Illinois Tollway Base Sheet Revisions

Section M	Base Sheet Drawings		
	Drawing	Modification Summary	Effective: 03-01-2023
	Pole Assembly (ITS)-Series 1000		
	M-ITS-1000	ELEVATION VIEWS POLE MOUNTED ITS ELEMENT ASSEMBLY

### ELEVATION VIEWS POLE MOUNTED ITS ELEMENT ASSEMBLY

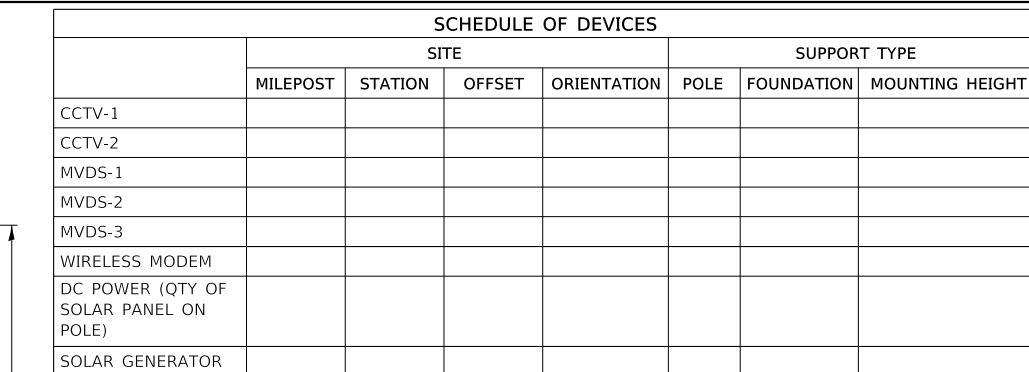
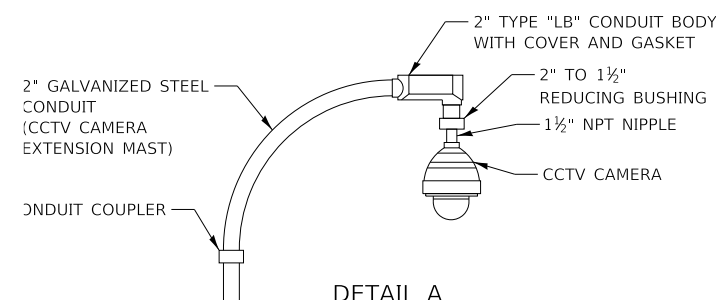
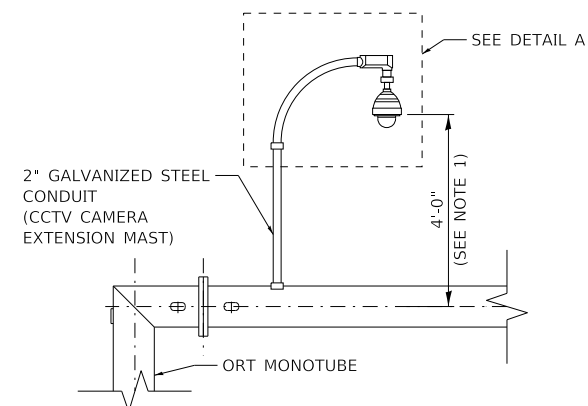
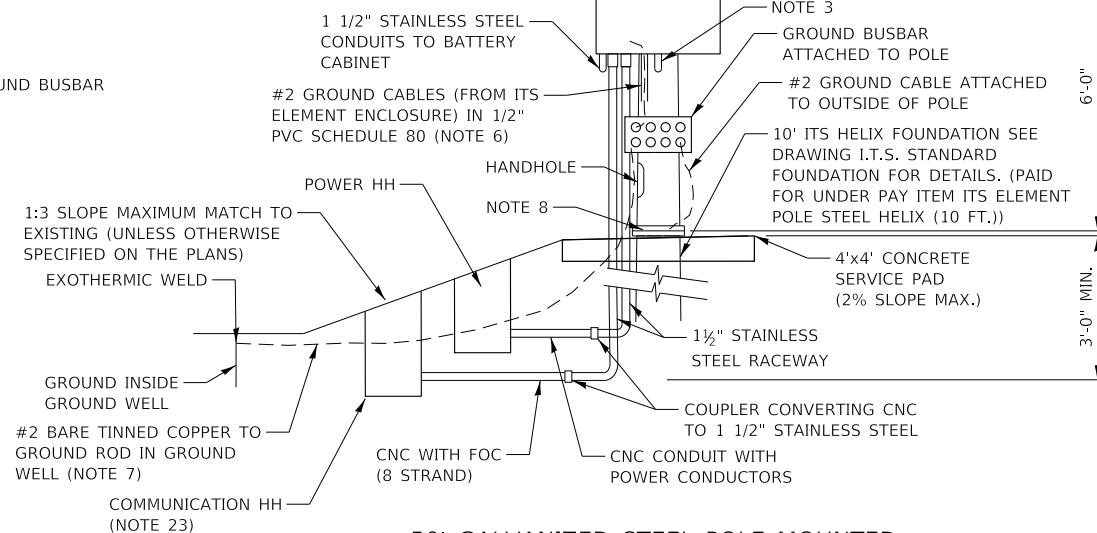
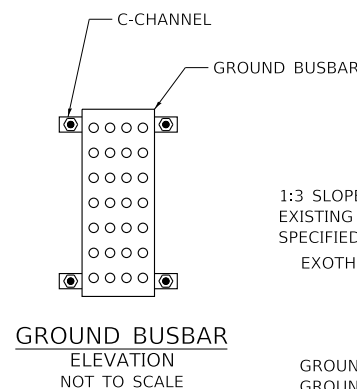
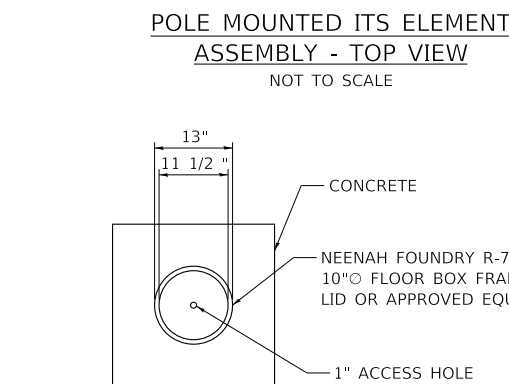
Sheet 1	Remove solar panels	
		Remove Note 3 to Designer: there is no more MVDS on solar and cellular option so the solar generator option was removed from this drawing	
		Remove the detail showing the battery enclosure and service pad for the battery enclosure	
		Remove the 2 cellular modem antenna and note on the elevation view	
		On the Enclosure Side View detail: remove the solar panel wires and remove battery equipment cabinet and remove Note 21, remove concrete service pad at the bottom of the battery cabinet

ITS CONCRETE SERVICE PAD

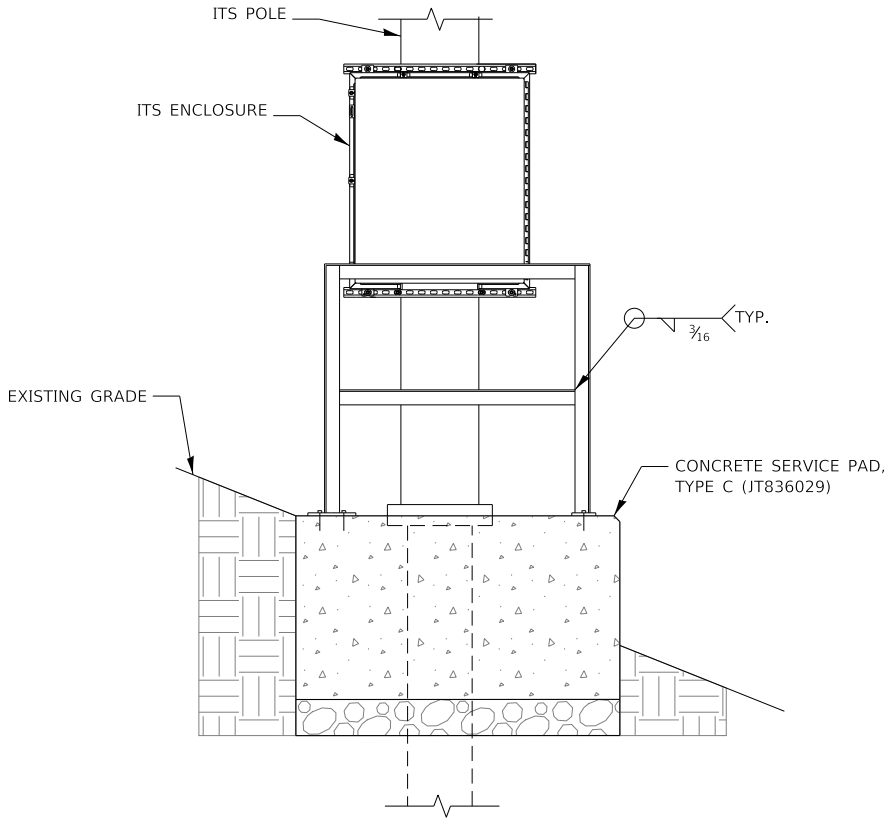
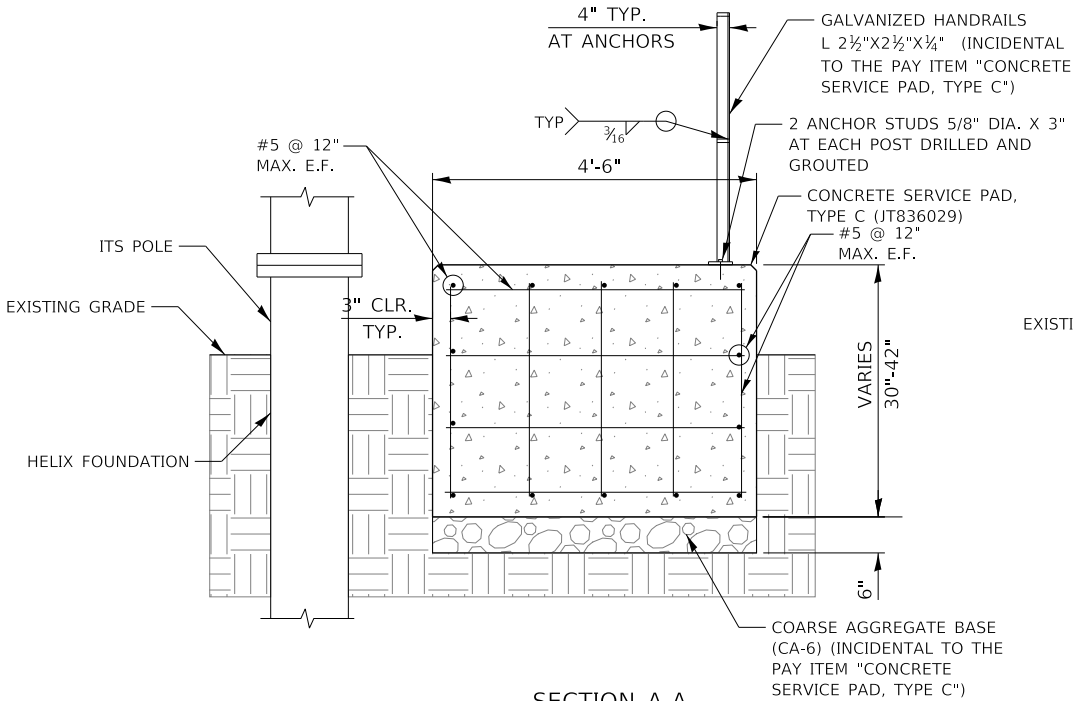
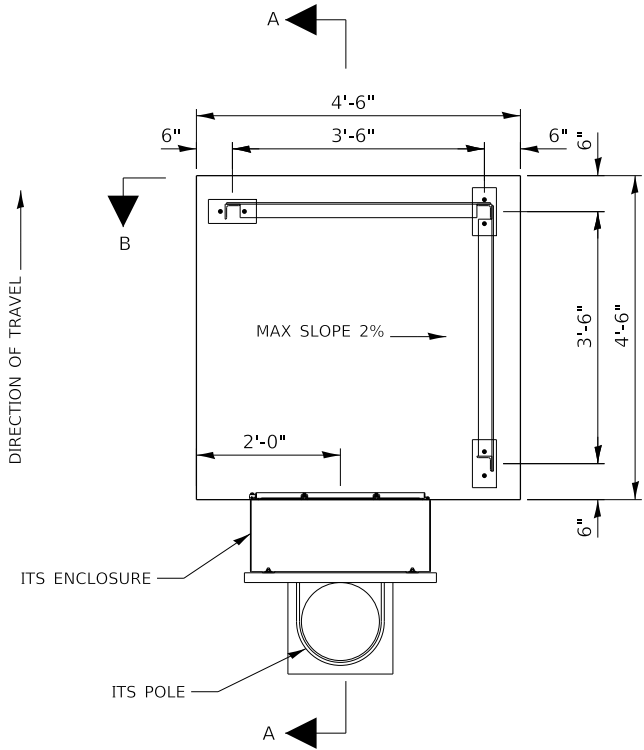
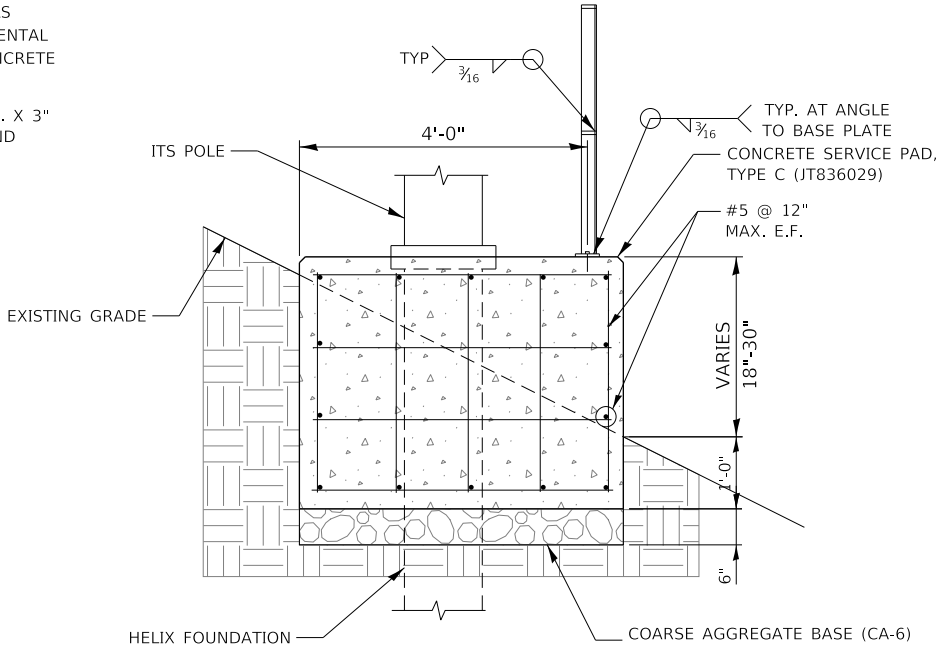
Sheet 1	For Section A-A (Type A): added a 1" clearance above surrounding terrain for Model A service pad	
		For Section B-B (Type A) added a 1" clearance above the surrounding terrain for Model B	
		For Section BB (Type B) added a 1" clearance of the top of service pad to the edge of the slope	
		Section B-B (Type A) adding: 1:2.5H max.	
		Section B-B (Type A) adding note: See plans for type of seeding class specified	
		Section BB (Type A) adding a note: Use 1:2 slopes for locations protected by guardrail or barrier wall of 1:6 slope for locations of the slope not protected by guardrail or barrier walls

Sheet 2	Revise Note 2 to add at the end of Note 2: "... when well beyond the clear zone"	
M-ITS-1004	CABINET LAYOUT AND WIRING ITS POLE MOUNTED ENCLOSURE (SOLAR POWERED 1-MVDS)		
<del>Sheet 1</del>	Drawing retired		
<del>Sheet 2</del>	Drawing retired

1. TYPE A SERVICE PADS SHALL BE INSTALLED ON SLOPES UP TO AND INCLUDING 1:6 (V:H).
2. TYPE B SERVICE PADS SHALL BE INSTALLED ON SLOPES GREATER THAN 1:6 AND LESS THAN OR EQUAL TO 1:3 WHEN WELL BEYOND THE CLEAR ZONE.
